Poynton Town Council Response to Planning Application 23/4152M – Poynton Pool Dam Embankment

Poynton Town Council Response to Planning Application 23/4152M – Poynton Pool Dam Embankment

Figure 2 Hyrad Image; 11th June 2016

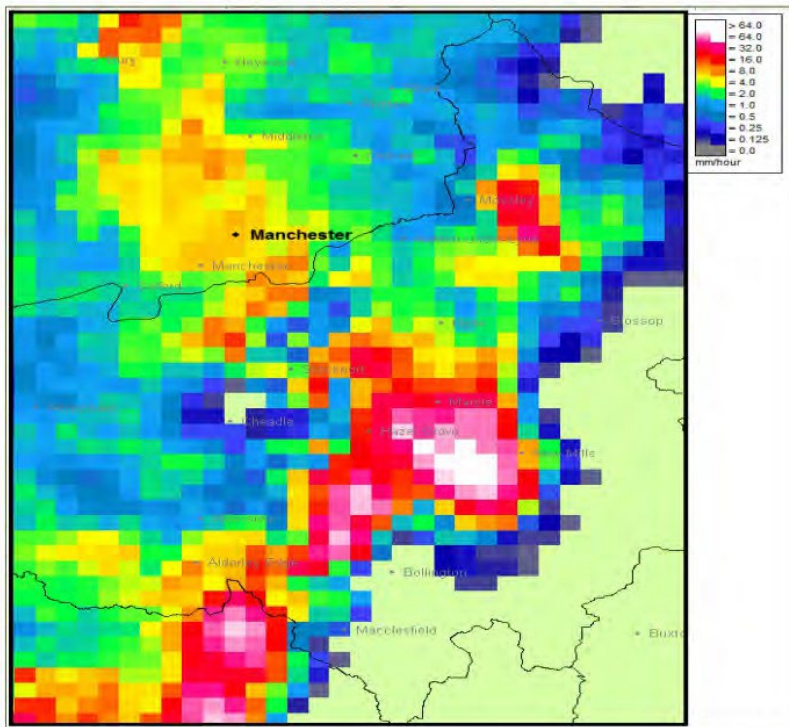
From the hyrad image it is clear to see that this rainfall fell within the catchment.

Figure 4-3 FN Frequency-Consequence Chart plot of societal risk

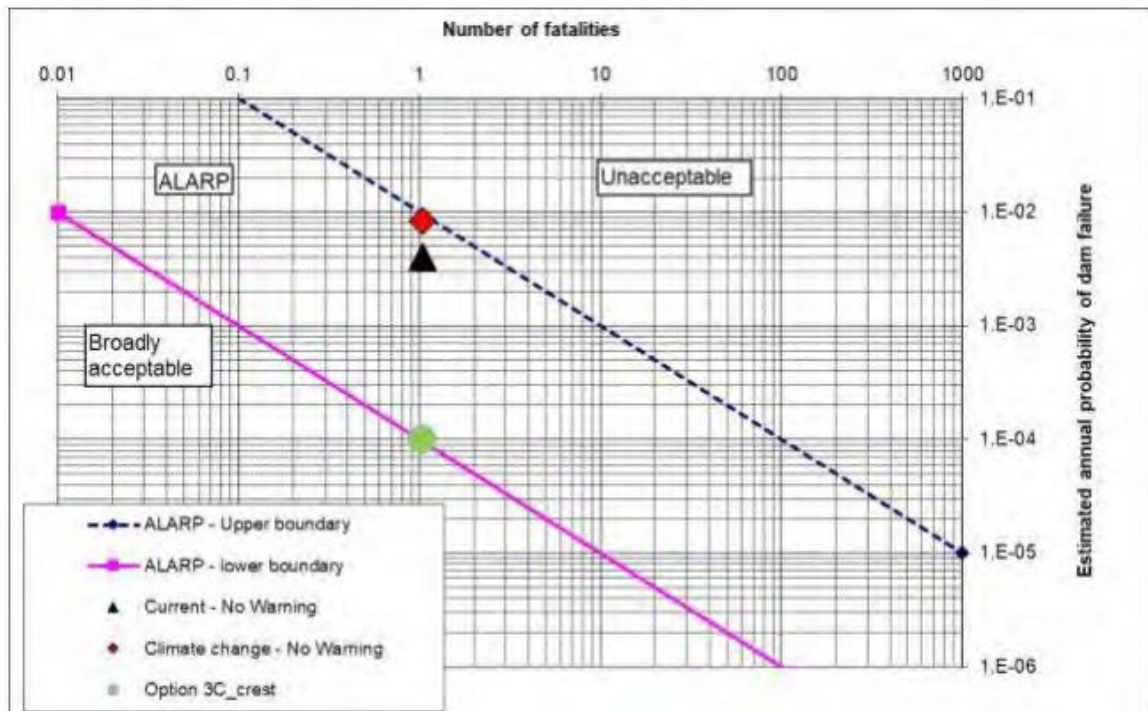
5.2 Section 1.4 and 1.5 of the Summary Options Report states that the risk of loss of life and property damage to those living downstream is unacceptably high. However, the Jacobs Initial Options report had to be amended following the discovery by Friends of Poynton Pool of a significant error showed that the risk was not in the unacceptable zone but actually in the As Low as Reasonably Practicable (ALARP) region. Please see below.

Fig 3: Jacobs FN plot (11/6/21, p31)

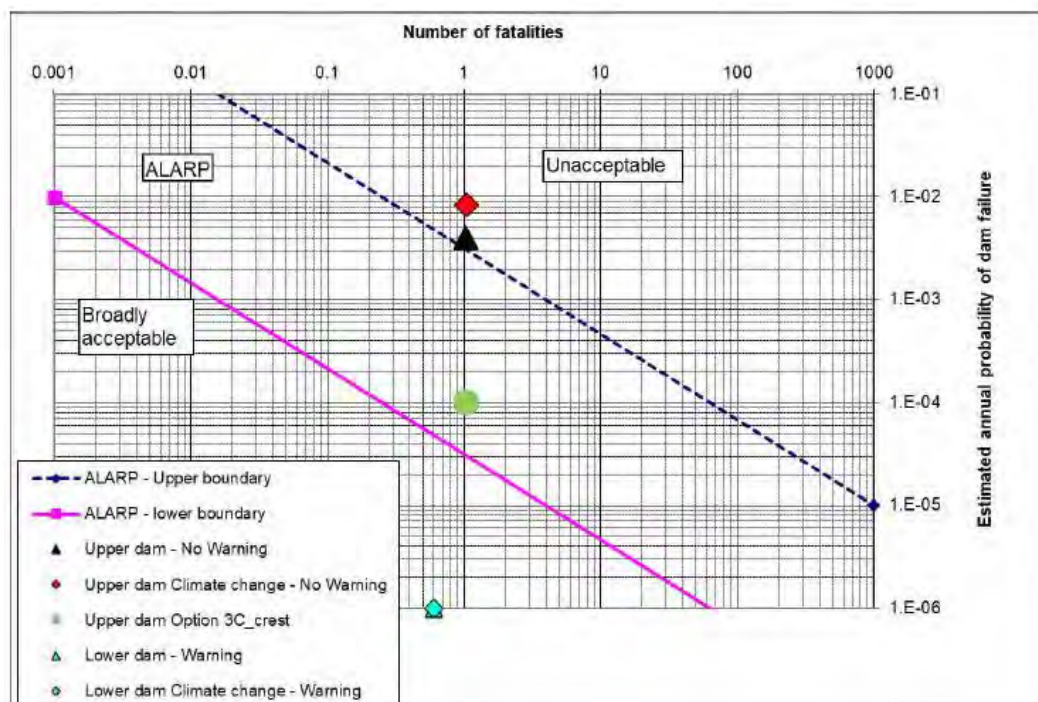
4.4 Figure 3 shows an FN plot as reported by Jacobs (p31). There are several points marked on it. The black triangle is the (1.04, $1/250$) point based on the likelihood of dam failure of $1/250$ per annum with 1.04 fatalities as reported by Jacobs. According to the Jacobs report this indicates that the current risk from the dam is unacceptable (because the point is above the upper dashed line). However, the line is not positioned according to the EA or HSE proposals and its origin is unknown. Were the HSE criteria for the position of the upper line used then the estimated current risk from the dam would be in the ALARP region.

4.6 It should also be recognised that FN lines and FN criteria are seldom strictly applied. Their main purpose is to provide information, not to regulate. In the case of Poynton Pool my

view is that considerations of acceptability or tolerability should be largely based on individual risk criteria and extended cost benefit analysis.
